KCIA Vision 2045 and Part 150 Study Airport Roundtable Advisory Committee Briefing

Vision 2045 – Draft Alternatives Phase 2

October 30, 2025

Non-standard airfield conditions: What we heard

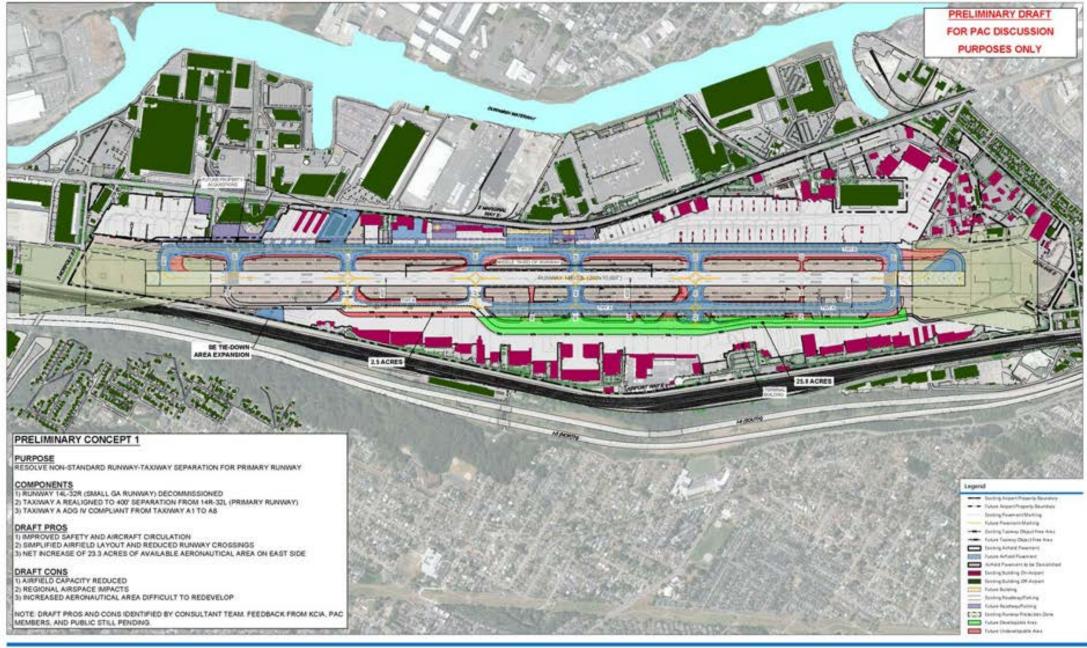
- Decommissioning the small runway will have negative impacts. It is a critical runway for light General Aviation in the Puget Sound region.
- Modifications to Taxiway A are unnecessary if crossings are maintained.
- This reduces aeronautical land without any real benefit.
- Would removing the small runway be better for residents in terms of noise?

Visibility minima: What we heard

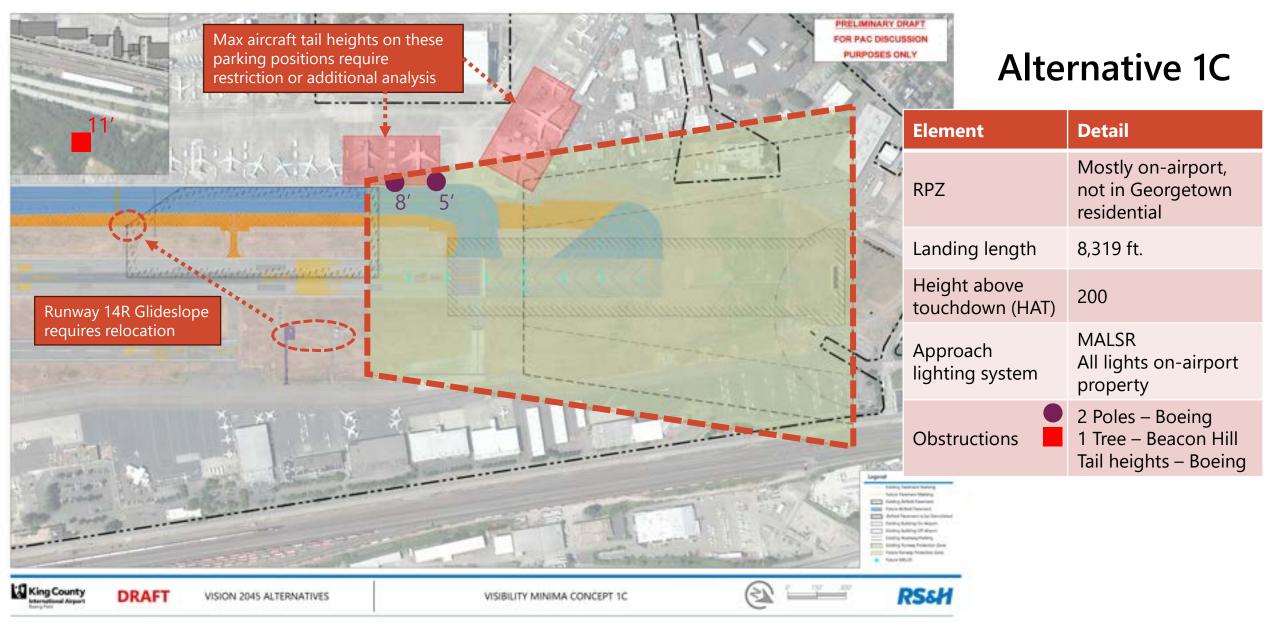
- No RPZ into Georgetown
- Keep MALSR on-airport
- Minimize/no tree removal or topping
- Minimize threshold displacement

- Improved minimums not needed
- Benefit of three-quarter mile likely not great enough to justify cost.

- Two new hybrid alternatives (1C & 1D)
- Both hybrids
 - Keep RPZ out of Georgetown residential areas
 - MALSR lights all on airport property
 - Reduce tree obstructions
 - Reduce landing lengths
 - Impact to Boeing ramp

Hot spot mitigation: What we heard

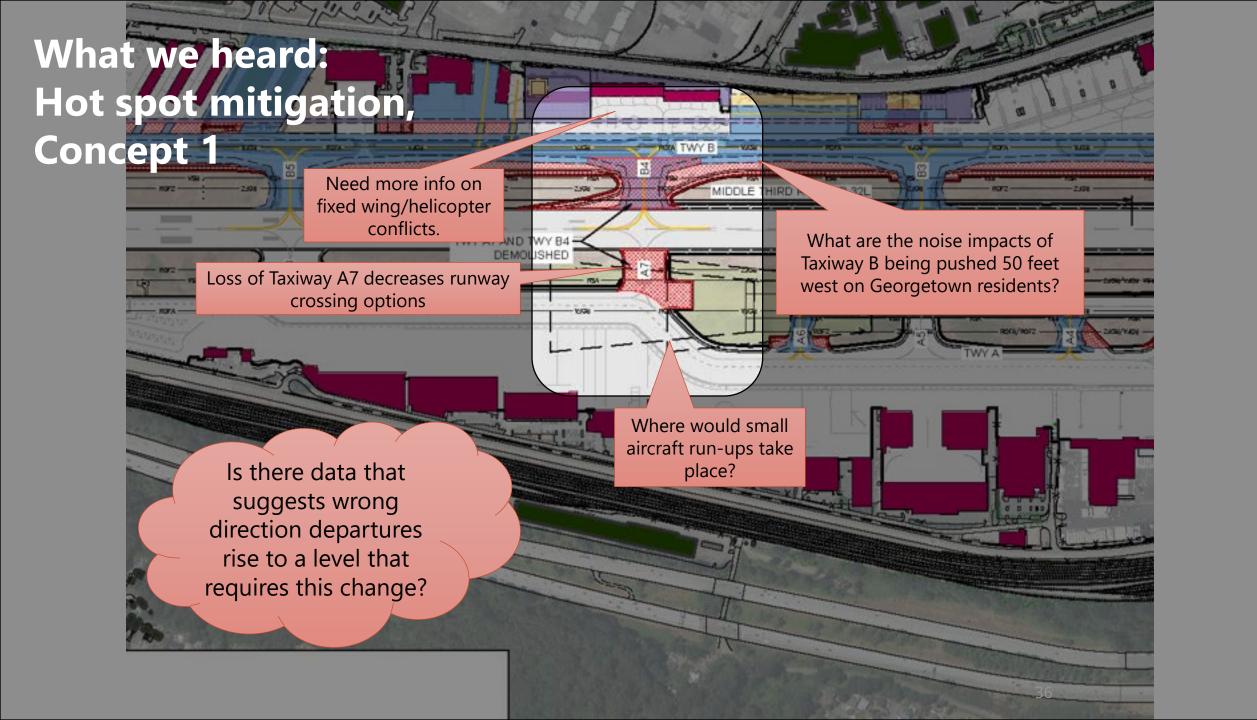
- Removing A7/B4 crossing not recommended adds to airfield congestion
- Increasing taxi time for large aircraft results in greater noise and emissions

What we heard: Terminal apron, Concept 2

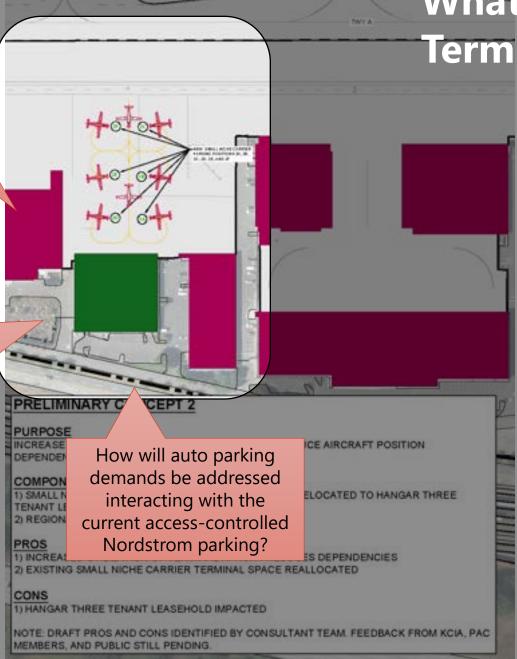
Passenger operations would be immediately adjacent to large corporate hangars

This would be a poor overall experience for carriers and their customers, and GA operations

Clarify reference to Hangar 3 LLC

Added costs for overhead and managing buildings

What provisions / improvements are needed for passenger access to/from aircraft?

What we heard: Terminal apron, Concept 3, cont.

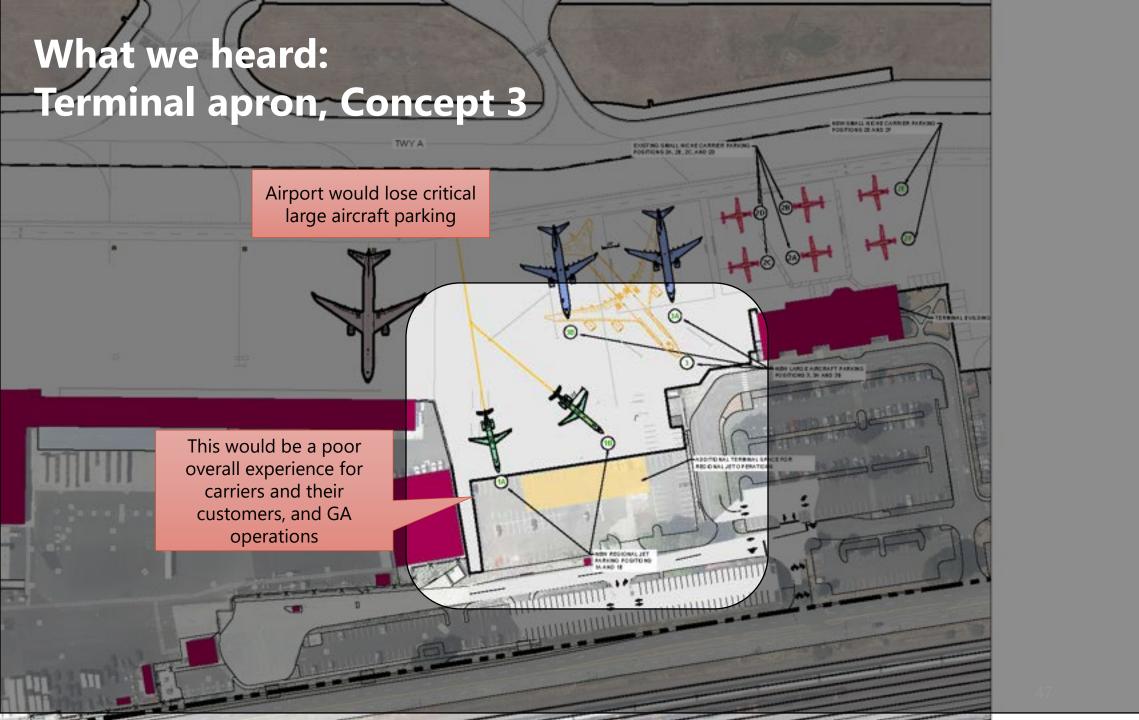
> Passenger operations would be immediately adjacent to large corporate hangars

Nordstrom parking not ideal if aircraft has to be pushed back with tug

Where would aircraft hold that are waiting for the Customs position to clear?

Added costs for overhead and managing buildings

- Does CBP have permission from tenant to relocate?
- Would CBP need to build a holding and retention facility to meet their standards?
- Is CBP's 24-hour access requirement compatible with tenant protocols?

- The study team is no longer considering relocation of terminal users south to Hangar 3/Nordstrom ramp. (Terminal apron alternatives 2 and 3)
- The two refined options are based on keeping terminal users in the main terminal area.
- These options provide six aircraft parking spaces for niche carriers instead of current four spaces.
- The new alternatives offer options for ramp and terminal space if a JSX type regional carrier enters KCIA in the near term.

Land use/airside: What we heard

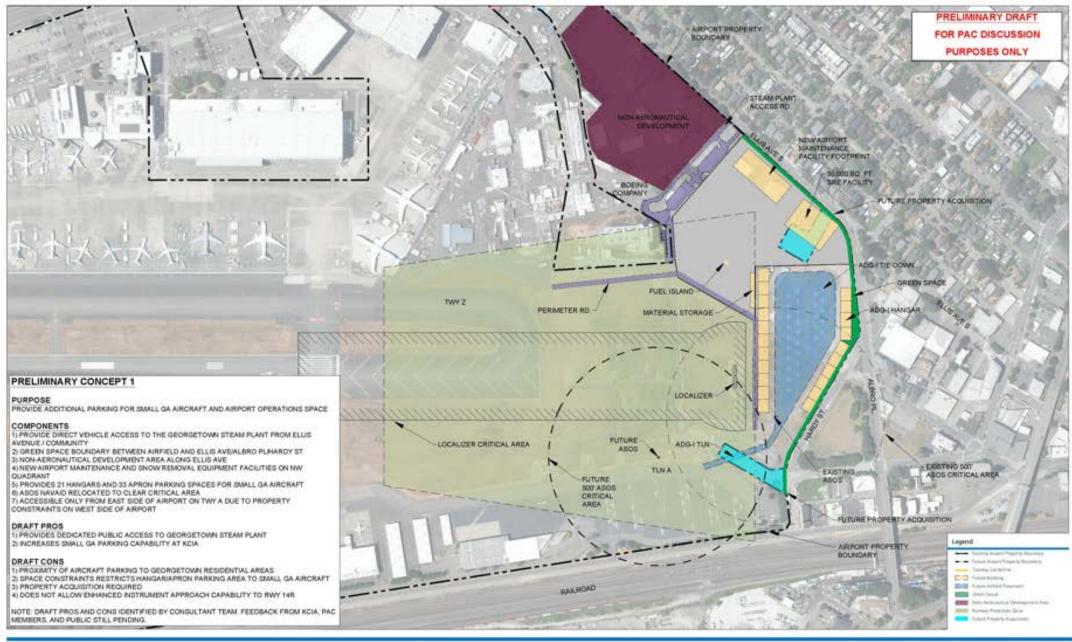
- NW Quadrant (Alts. 1 and 2)
 - Highly beneficial to light GA community. Where is Fuel island accessibility?
 - Can Taxiway Z be extended for light GA aircraft?
 - Detrimental to health and quality of life for Georgetown residents. Not fair to all parties.
 - Why can't tie downs go to the south end of the airfield?
 - Residents do not want a new access road to the Steam Plant.
 - Noise impacts to residents / hangars do not block noise.

Land use/airside: What we heard, continued

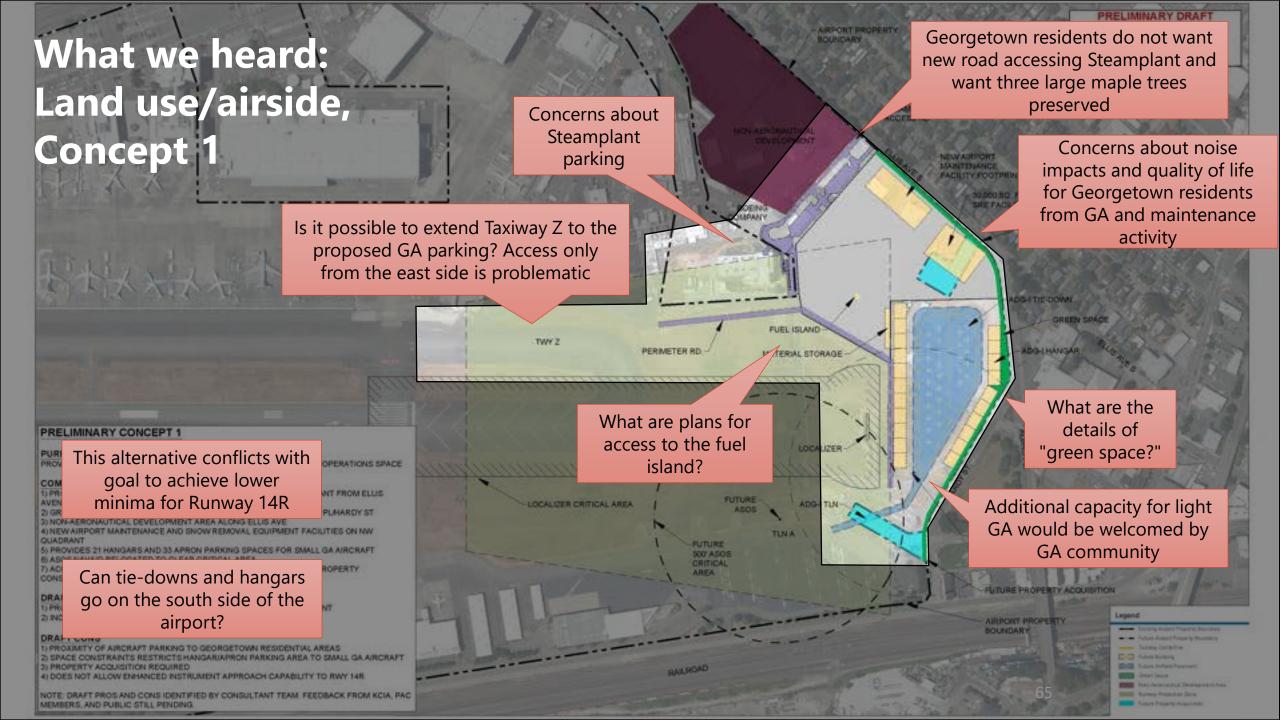
- SW Quadrant (Alt 3)
 - Potential conflict with Museum of Flight easement.
 - Unacceptable loss of GA parking area.
 - Only viable if Alternative 1 or 2 is pursued to replace loss of GA area.
- Vertipad Options (Alt 4)
 - Can't tell what would be displaced.
 - Location closest to terminal if commercial operators. Need more information.
 - FBOs likely location across industry to initiate.
 - Where would options #2 and #3 fly over our houses?
